Rattle or Wind Noise From a Front Door Panel

(Supersedes 01-048, Rattle From a Front Door Panel, dated July 2001)

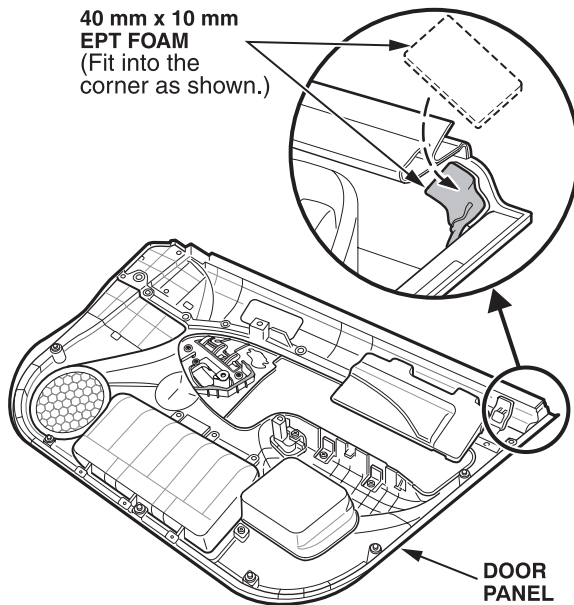
1. Remove the affected door panel. Refer to section the 2001 Civic Shop Manual.
2. Cut two pieces of wool felt: one 135 mm x 25 mm and one 30 mm x 25 mm.
3. Apply the pieces of wool felt to the ribs as shown.
